Clause 82 LPI Transmit diagram

Jeff Slavick – Avago Technologies

Recommendation for D1.2 comment #202

Figure 82-16 LPI Transmitt state diagram

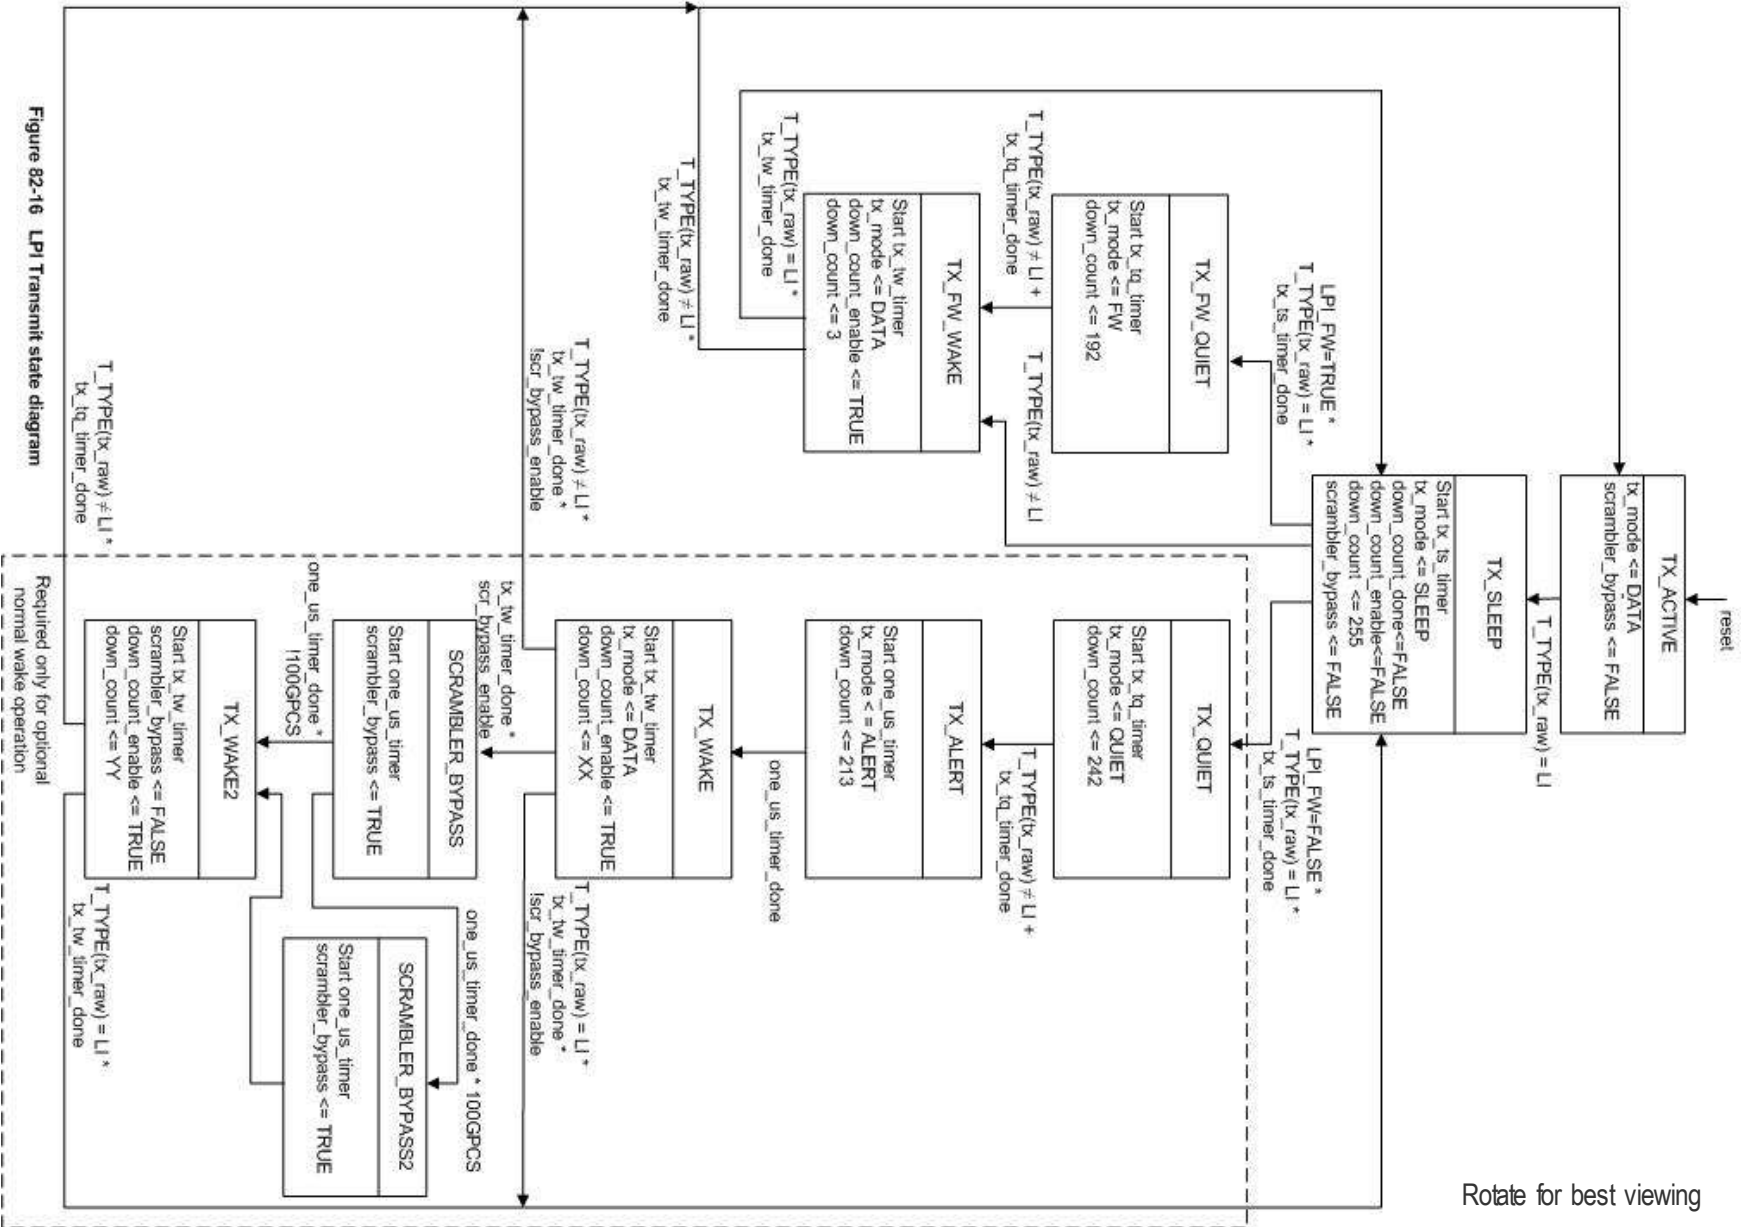
Problems with D1.2 scheme

- **Clause 74 FEC require unscrambled IDLE or LPI characters to be sent for Rapid Framing when exiting the RX_QUIET state.**
- **802.3az we only dealt with FEC on 1 lane and not 4+ trunked lanes**
 - 40G/100G we first have to FEC block_lock, then the PCS can begin framing and acquire align_status. PCS needs RAMs to quickly acquire align_status
- **Rapid Alignment Markers are not // or /LI/ characters**
- **100GBASE-CR10 uses 20 PCS lanes operating over 10x10G PMD lanes, so you only get 1/2 the data in the same wall clock time**

New states for FEC support for normal wake

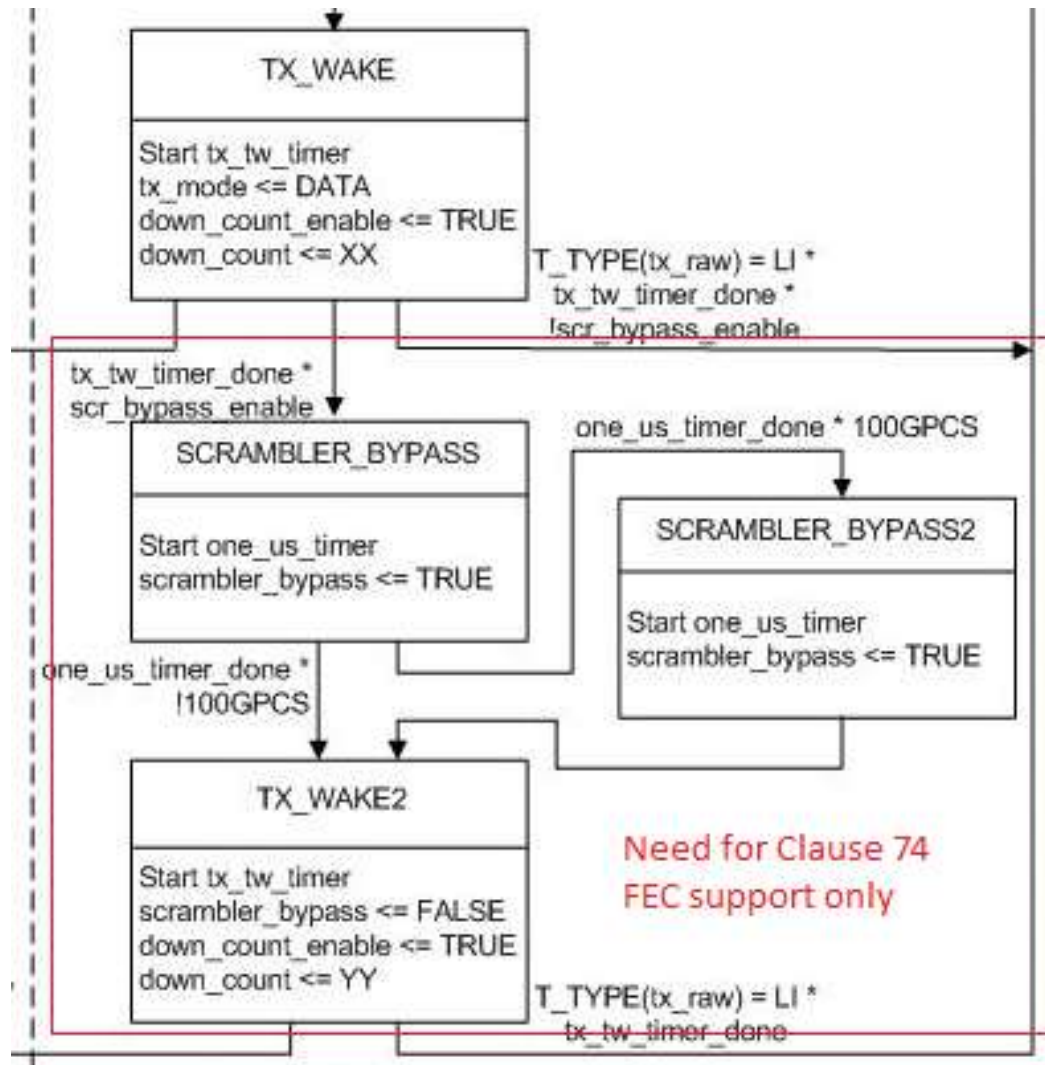
Why do you need TX_WAKE2

- **40G and 100G PCS have multiple PCS lanes that are trunked together unlike the Clause 49 10G PCS.**
- **The FEC blocks run on individual PCS lanes, and the FEC scrambles the PCS scrambled data.**
- **So you need to achieve FEC frame lock on each FEC lane before you can begin to align the PCS lanes.**

- **TX_WAKE provides time for the Rx to “wake”**
- **SCRAMBLER_BYPASS* provides time for the FECs to frame**
- **TX_WAKE2 is the time for the PCS to frame and deskew**

Why do you terminate RAMs before SCRAMBLER_BYPASS

- The FEC blocks rely on looking for a known data pattern.
- The known data patterns rely on the FEC frame 66b blocks being composed of IDLE or LPI characters
- If you send RAMs during SCRAMBLER_BYPASS then it's possible the RAM will be the first 66b block of a FEC frame. When that occurs you only get a 24b known data pattern, which is insufficient to prevent aliasing to scrambled data.
- Also if RAMs are sent during SCRAMBLER_BYPASS and the FEC is expected to use the RAM as a known data pattern that increases the number of patterns from 2 to 26 that the FEC has to look for. (20-100G AMs and 4-40G AMs)

- **Adopt the diagram shown in slide 5 as the new Tx LPI Transmit state diagram**
 - This requires the creation of a state variable denoting if the PCS is a 100GPCS in clause 82
- **Adopt the changes presented in slide 16 (Option2) for the Twl time durations of TX_FW_WAKE, TX_WAKE and TX_WAKE2 states**
 - Normal wake times are 5.1 μ s, 5.1 μ s, 6.2 μ s for non-FEC, 40G+FEC, 100G+FEC
 - The value down_count is initialized to is included in the table, but should not be inserted into Table 85-2a, however Figure 82-16 diagram needs to be updated to reflect the values provided in the table.

Why do we need SCRAMBLER_BYPASS2

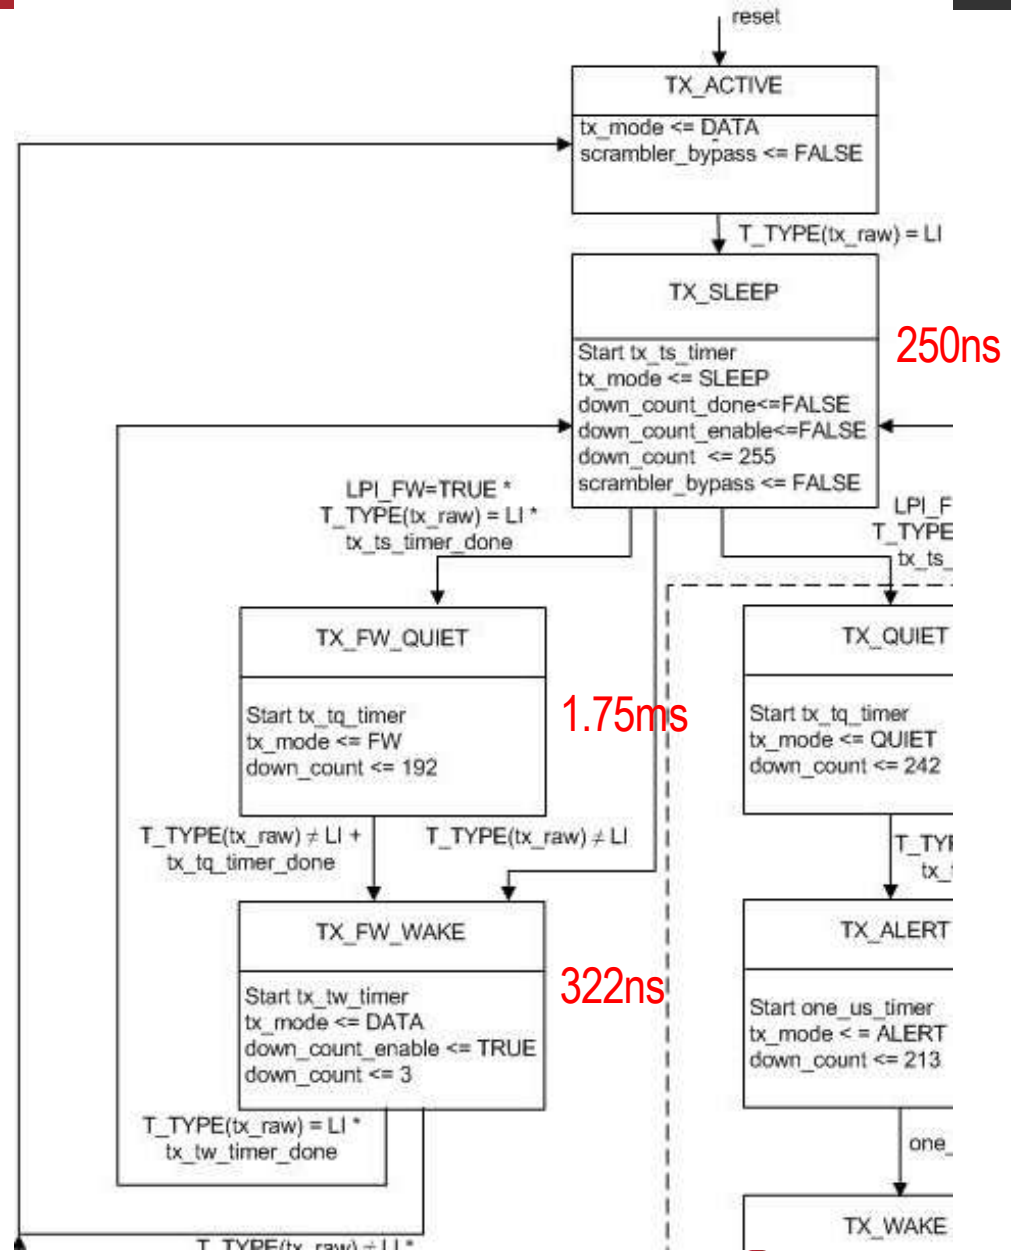
- **100GBASE-CR10 uses 20 PCS lanes running at ~5G and 20 independent FEC instances (one per PCS lane)**
- **1.1 μ s of scrambler_bypass duration provides 5 full FEC frames when running at ~10G**
- **If 100G uses a single 1.1 μ s duration then each FEC will be guaranteed to see 2 full FEC frames (instead of 5)**
- **You need 5 FEC frames, and here's what each is for:**
 - Frame 1 -> could be corrupted so you can't rely on it, and you want to avoid RX_WTF at all costs
 - Frame 2 -> match known data pattern frame
 - Frame 3 -> time to actually frame
 - Frame 4 -> 1st validly aligned frame
 - Frame 5 -> 2nd validly aligned frame, assert fec_block_lock and signal_ok. PCS waits for signal_ok assertion before it begins it's framing process.

Why do you need SCRAMBLER_BYPASS2 cont.

- Using time in TX_WAKE2 is an option, but would have to be specified how much time is allotted for the FEC to frame so PCS designers know how much time the PCS will have to achieve align_status = true.
- By extending the scrambler_bypass time to 2.2 μ s for 100GBASE-CR10 operations the EEE Clause 74 FEC design is the same for 10G-KR, 40G-KR4/CR4 and 100G-CR10

Normal Wake With a Clause 74 FEC Option 1

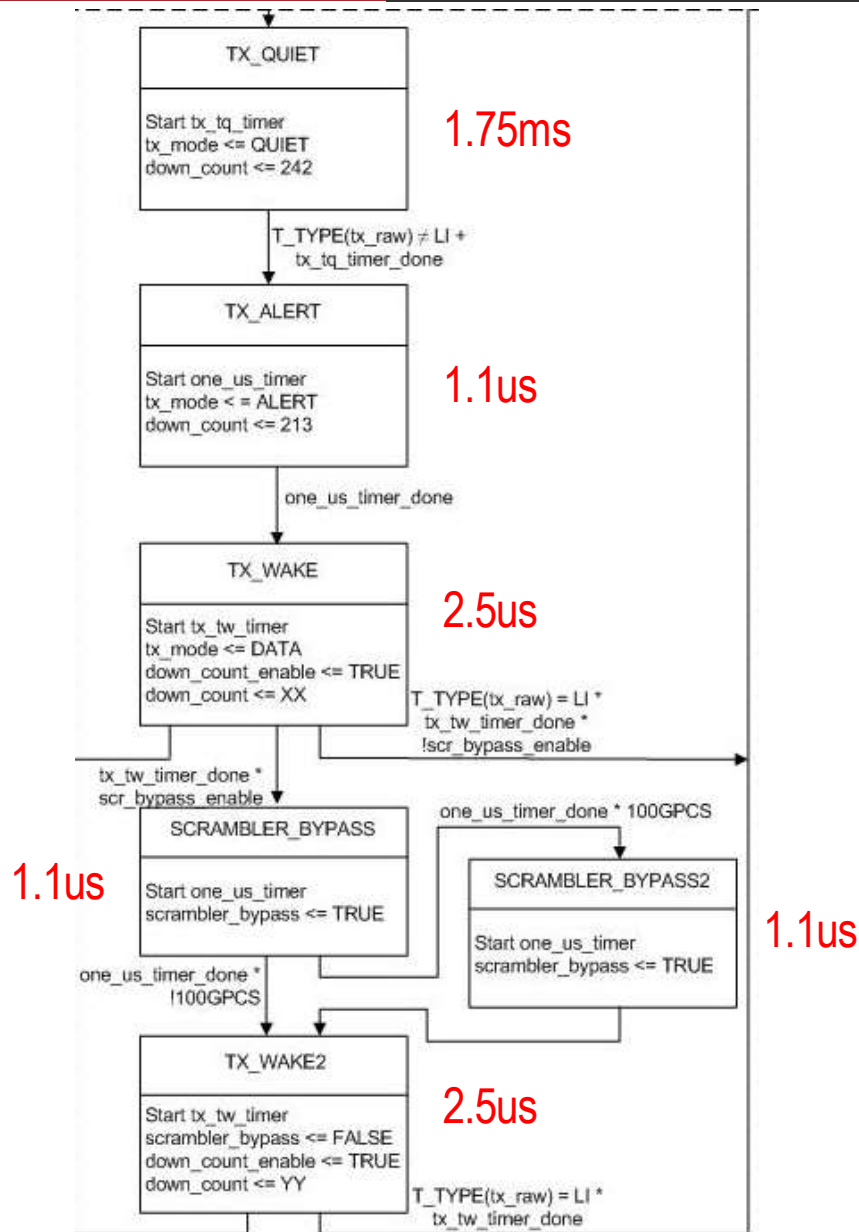
Minimum time for the Tx to exit Low Power Mode when LPI_FW = FALSE is 322ns

Maximum time for the Tx to exit Low Power Mode when LPI_FW = FALSE and scr_bypass_enable = TRUE is 6.1 μs for 40G

Maximum time for the Tx to exit Low Power Mode when LPI_FW = FALSE and scr_bypass_enable = TRUE is 7.2 μs for 100G

- Using these durations extends wake for PHYs that include a Clause 74 FEC from 5.1 μ s to 6.1 μ s (40G) and 7.2 μ s (100G)
- The wake time for 100GBASE-KR4, 100GBASE-CR4, 100GBASE-KP4 remain the same as D1.2 at 5.1 μ s when normal wake is enabled.

Normal Wake With a Clause 74 FEC Option 2

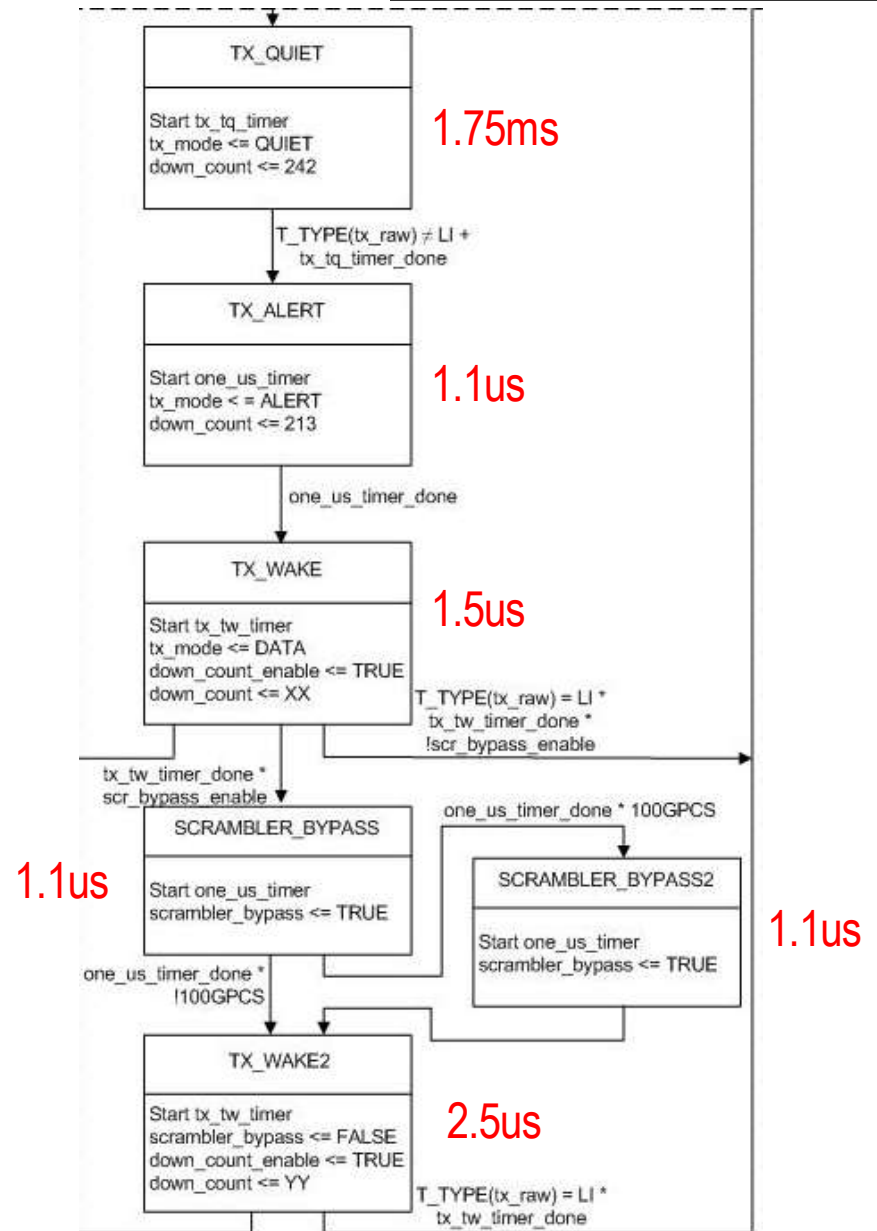
Minimum time for the Tx to exit Low Power Mode when LPI_FW = FALSE is 322ns

Maximum time for the Tx to exit Low Power Mode when LPI_FW = FALSE and scr_bypass_enable = TRUE is 5.1 μs for 40G

Maximum time for the Tx to exit Low Power Mode when LPI_FW = FALSE and scr_bypass_enable = TRUE is 6.2 μs for 100G

- Using these durations extends wake for PHYs that include a Clause 74 FEC from 5.1μs to 6.2μs for 100G only (40G remains at 5.1μs)
- But this reduces the duration the Rx gets to “wake” and provide “good” data from <3.6μs to <2.6μs (TX_ALERT + TX_WAKE) for 40G and 100G PHYs that are using Clause 74 FEC
